SERVICE BULLETIN

SB1332

VEHICLE MODEL: TD925US

SUBJECT : To replace backrest of rear bench outer seats

Figure 1: Identification of components

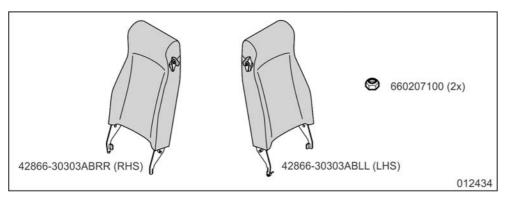
- On above mentioned vehicles the backrest of the rear bench outer seats must be replaced to improve the safety belt installation of these seats.
- To address this issue, Van Hool is conducting a Field Change Program, the terms and conditions of which are explained further on under "Warranty".
- Owners and operators of the affected units should change the backrest of the rear bench outer seats as explained in this service bulletin.

VH Reference	Description	Qty.
42866-30303ABLL	Seat backrest LHS	1*
42866-30303ABRR	Seat backrest RHS	1*
660207100	Self-locking nut	2*
